Planning Board Meeting

October 17, 2023

ASSISTANT PLANNERS REPORT

ASSISTANT PLANNER REPORT

| Case #: | 23-032SPA-SP-RM |

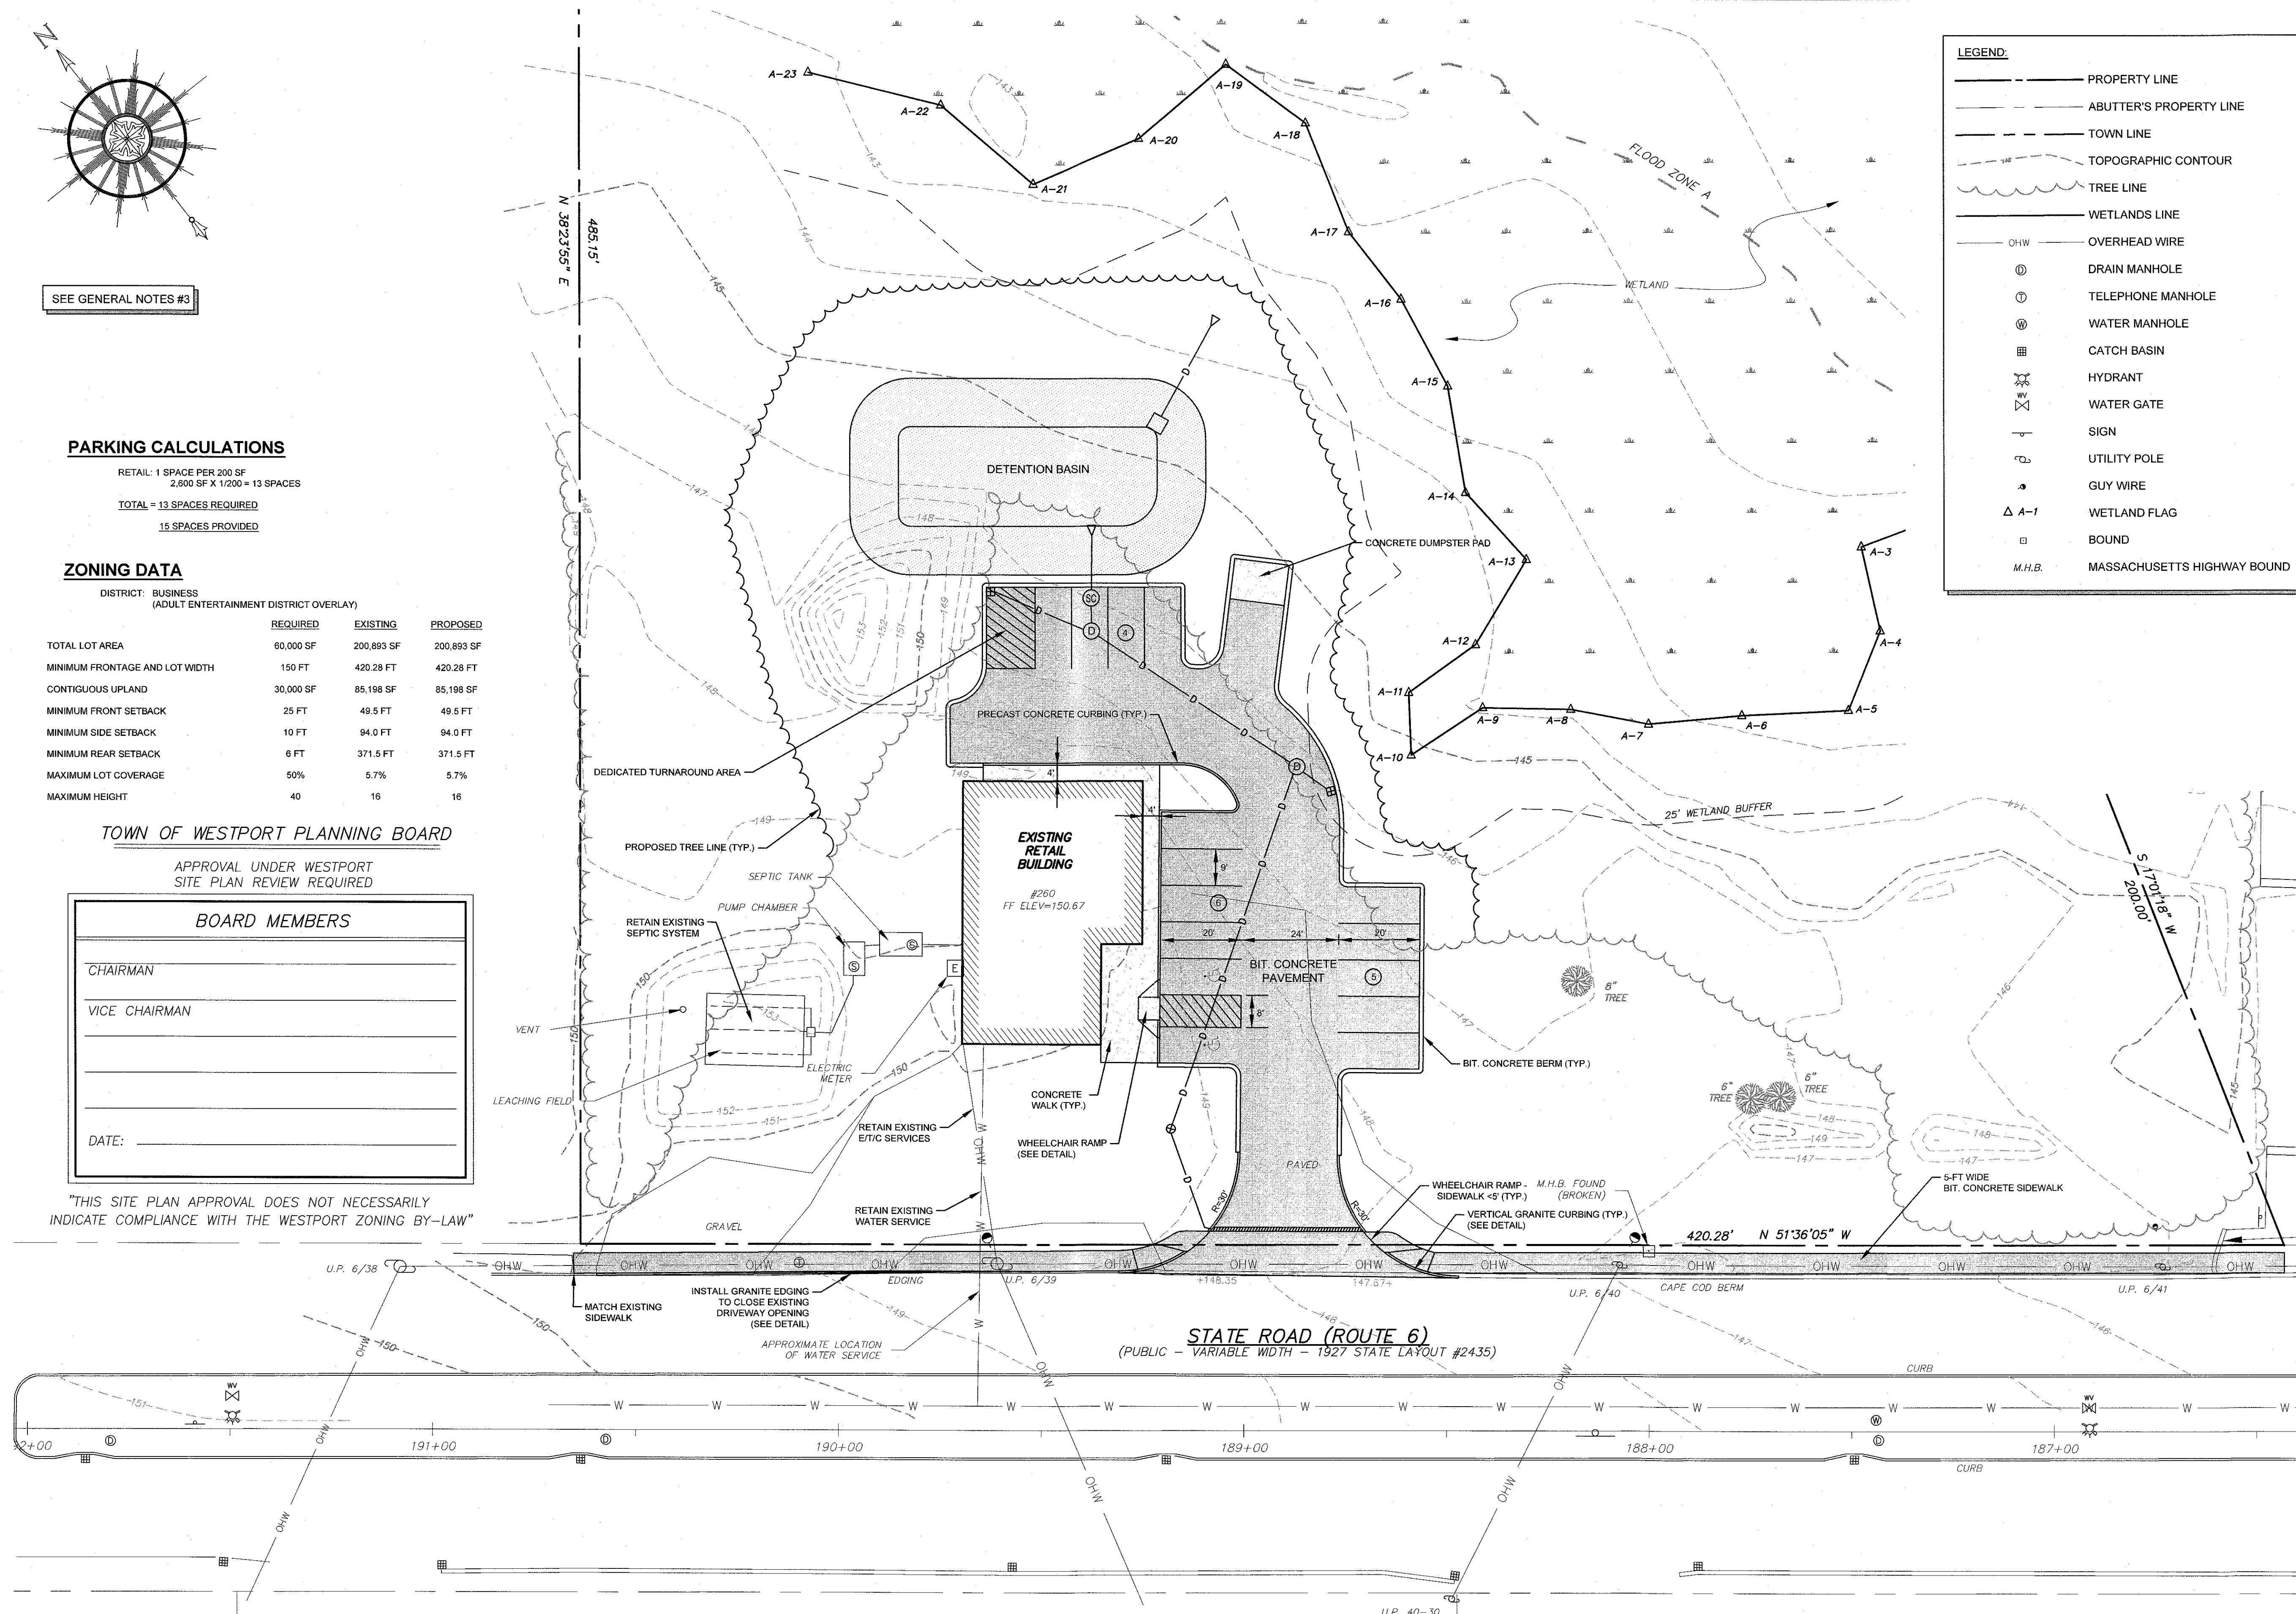
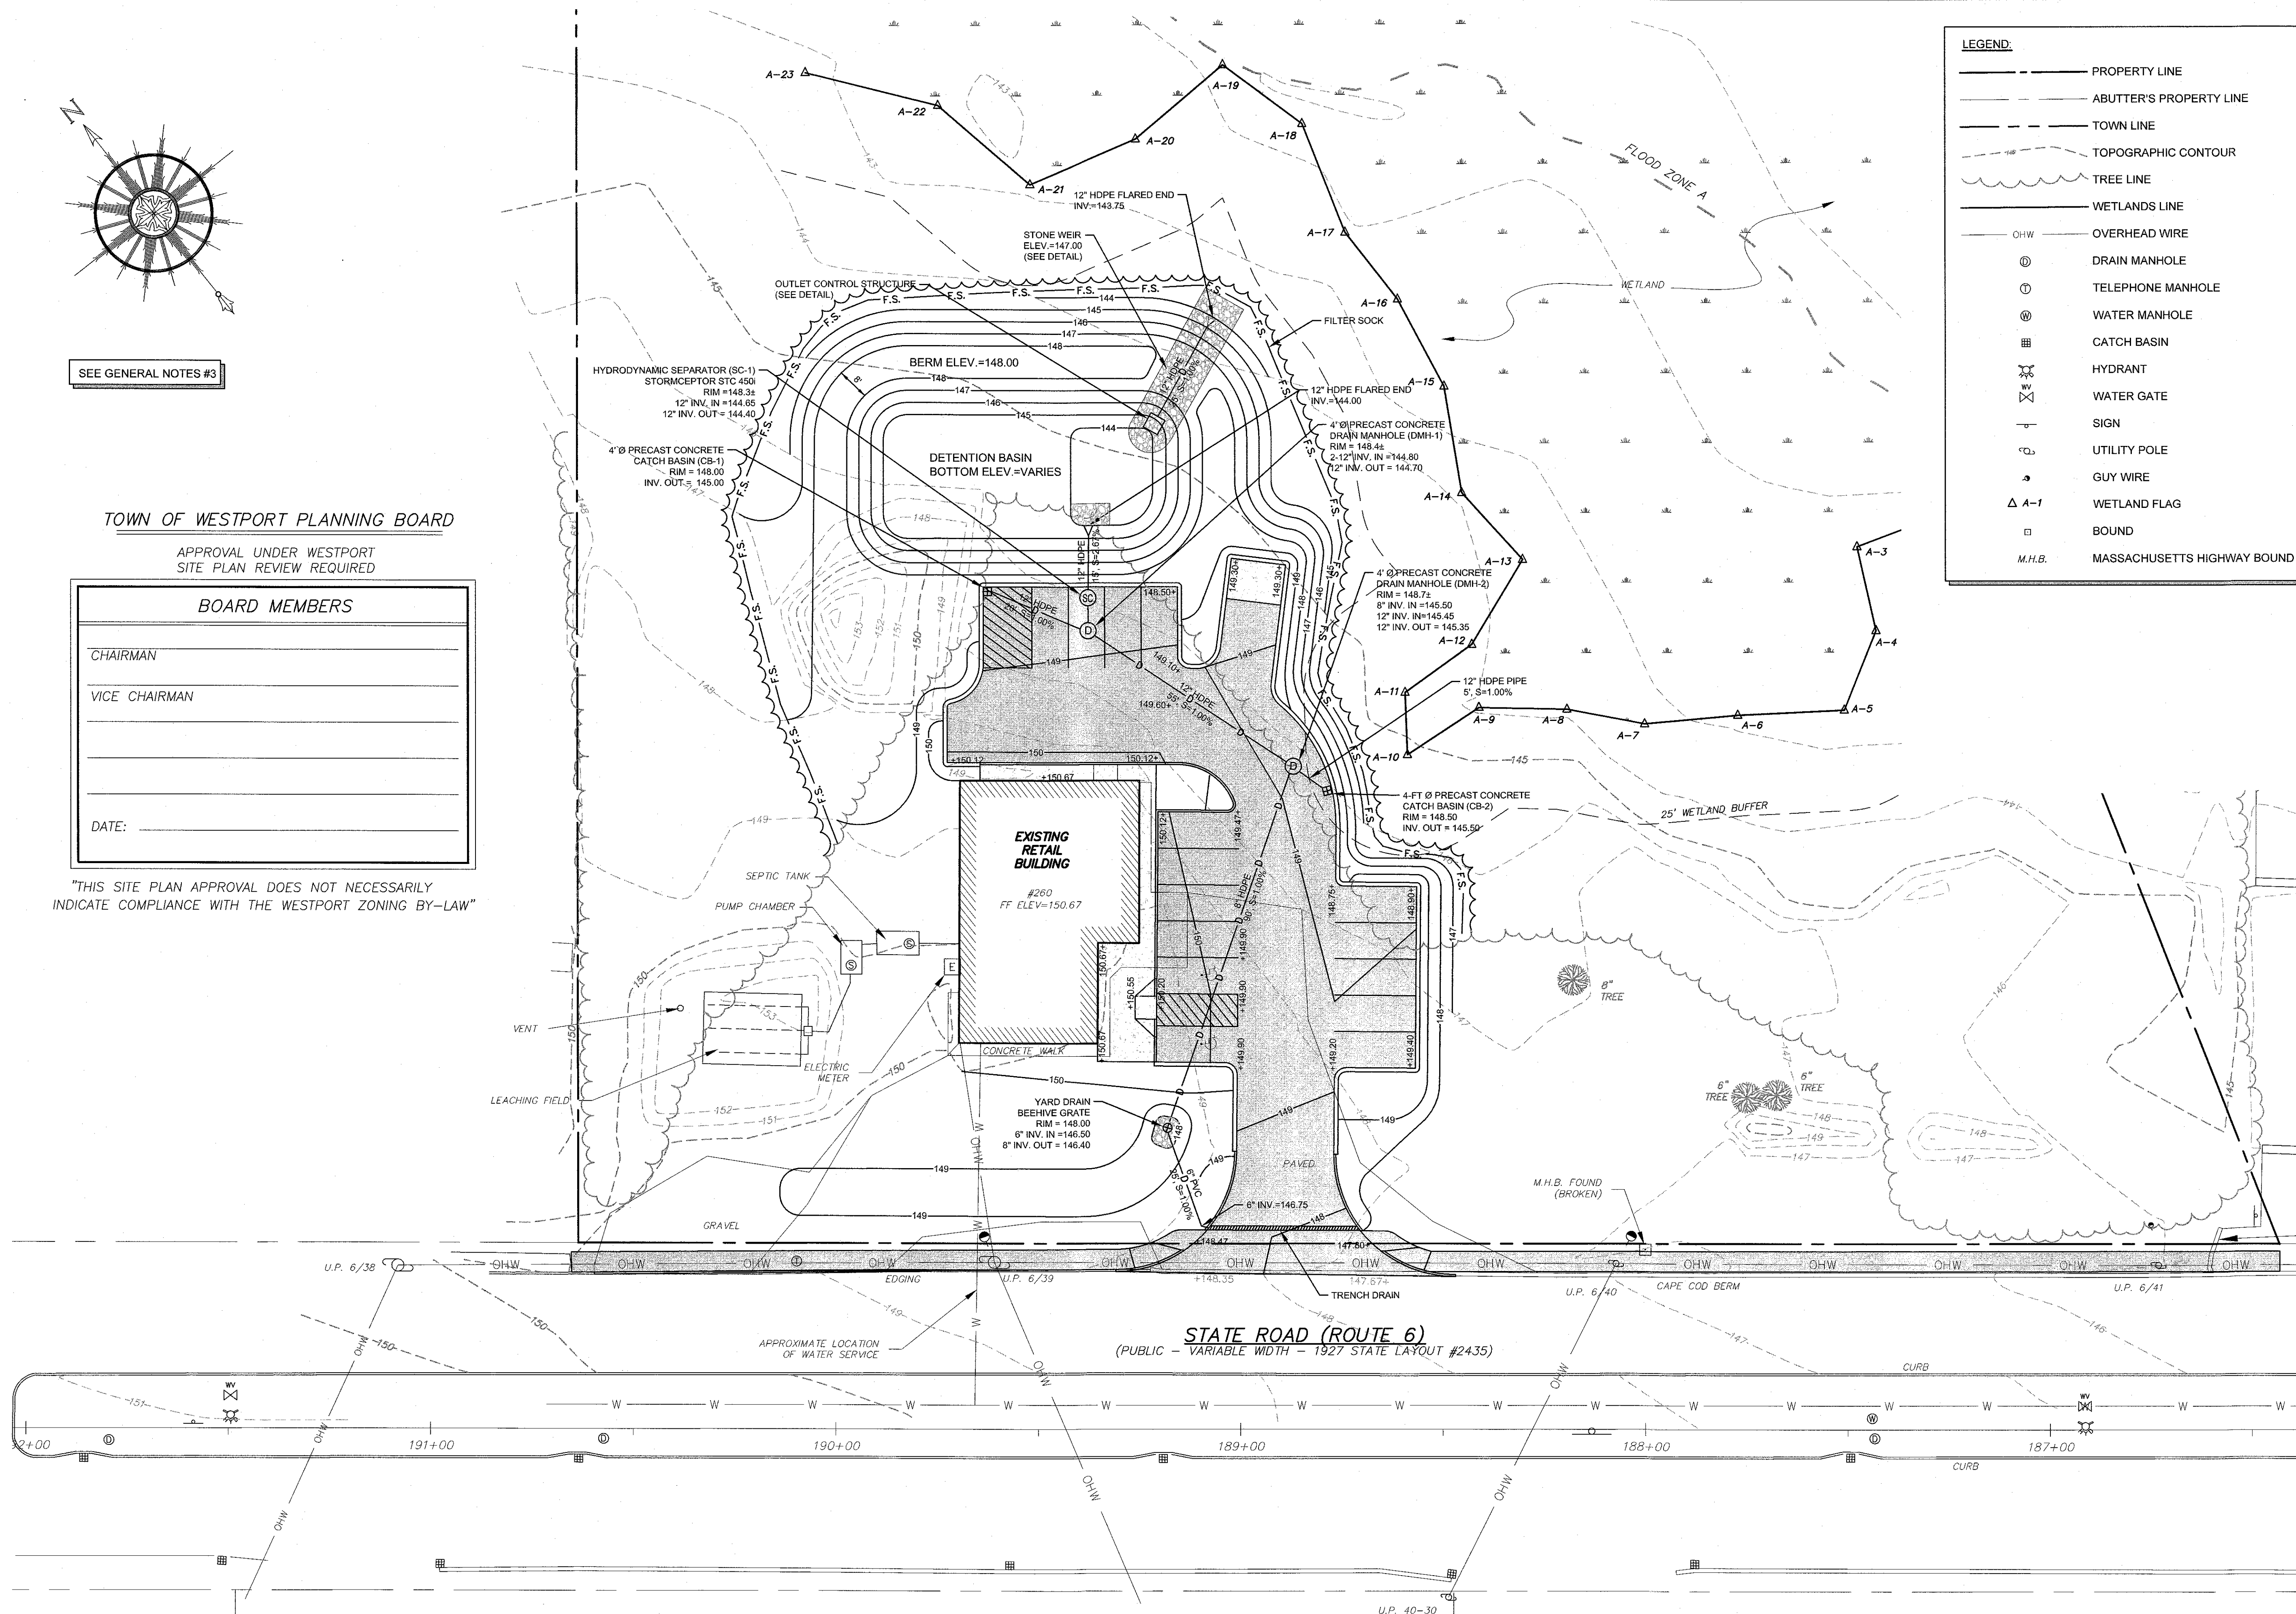
- **Wall pack lighting is to be located at strategic locations on the building for safe vehicular and pedestrian movement during hours of low sunlight and darkness. Model details of lighting should be provided to the Planning Office.**
- **Sidewalks are also present along State Road that further allows safe pedestrian movement onto and off the site. Sidewalk should be connected from the business to the sidewalk network.**
- **A bus stop is located a few hundred feet down State Road from the site, which will also allow for the safe movement of people wishing to enter or exit the bus from that location.**

- **Fire control for the building via fire hydrants on State Rd. (approximately 200' to the west and 260' to the east). Access to the building shall be via a new access drive and aisle to east and north of the building as well as State Road. **The applicant still needs to provide the Fire Department and Building Department with a code synopsis before the Fire Dept. will sign off on the project design.****
- **Utilities will be above ground**
- **Stormwater drainage calcs are included in the submission to address runoff associated with the site and impervious surface areas.**

- **No removal of stone walls is proposed as there are no stone walls located on site.**
- **Stormwater flow and drainage calcs have been provided to account for flooding, and other impacts of stormwater and soil erosion. **A temporary erosion control plan for construction should be provided, especially in the areas closest to the BVW.****
- **The site is located on State Road and all business will be conducted within the building, therefore noise and light pollution will not be factors for this proposal.**
- **The Conservation Commission noted that the proposed design is closer than the 25' to the BVW than is recommended and stated that the site has a history 21E site clean-up as the former "Beanos Garage".**

- This site is located along State Road (Rte. 6) which is located in the business district and has an extensive amount of automobiles traveling along the corridor already.
- The proposed parking is to the side and rear of the building which will help minimize light intrusion and the glare from headlights facing the State Road.
- The applicant has provided a landscaping plan depicting shrubs and greenery along the front of the building and parking lot to provide screening from the roadway. **The trees on the existing landscaping plan are 2.5" caliper, the trees should be 3" caliper.**
- **The landscaped buffer of the parking lot should be 20' deep, the current plan depicts a 10' depth.**
- **The landscaping plan should include tree plantings along the roadway.**

- The location of the dumpster pad/ enclosure on the plan is located to the rear of the site and adequately away from the entrance of the building and view from the roadway. **Enclosure materials for the dumpster area should be provided to the Planning Office and listed on the plan.**

Staff Recommendation: Staff recommends that the project be continued to a date and time certain in order receive the consultant review from S.W. Cole and address outstanding items as mentioned in this report and any items mentioned in S.W. Cole's review. The applicant will need to revise plans and provide further information.
